# Access Compliance Report

## Public Rights-of-Way

### (Curb Ramps)

Intersection ID: 47971	Main Street: SOUTH_CREEK_RD	Cross Street: KYRENE_RD	Location: S
ADA ID: 577E4C103BDE	Ramp Type: BlendTrans1	Initial Pass/Fail: Fail	Overall Compliance: No
		Severity Score: 8.75

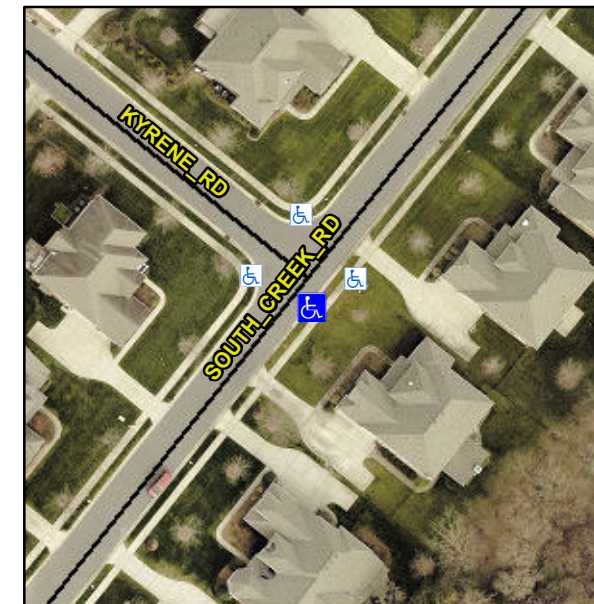
**R304.5.1**

**Remove & Replace Curb Ramp With Two New Directional Ramps or Equivalent.**
